# Blue Print ADG02342

Kia Sedona 2.9DT (UP751 Model),  
Hyundai Terracan 2.9DT 2001>2007

## Kia Sedona, Hyundai Terracan - Fuel Filter Replacement

Kia Water Sensor - 0K52A-23-430

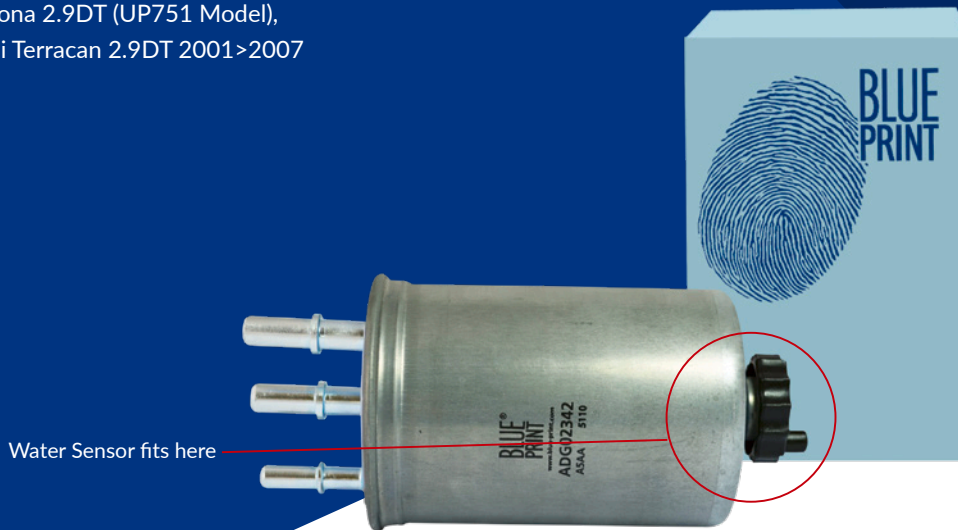
We have received some questions regarding fuel filter ADG02342, which is listed for the Kia Sedona and Hyundai Terracan. There were concerns that the filter could be incorrect for the applications as it is slightly different to the OE filter being replaced, as the water draw/sensor hole is too small to allow the electronic sensor to be fitted.

Our research has shown that both Kia and Hyundai carried out a modification to the fuel filter and water sensor. From approximately 2006 both applications now have a smaller diameter threaded hole for the water sensor.

The water sensor hole on ADG02342 measures M8x1.25.

Blue Print now only supplies **ADG02342** to the new modified OE specification. Therefore, if the original fuel filter fitted to the vehicle has a larger sensor/drain hole, you will be required to purchase the new modified design of water sensor which is only available from OE.

- New Kia Water Sensor OE number = 0K52A-23-430
- New Hyundai Water Sensor OE number = 31396-H1950
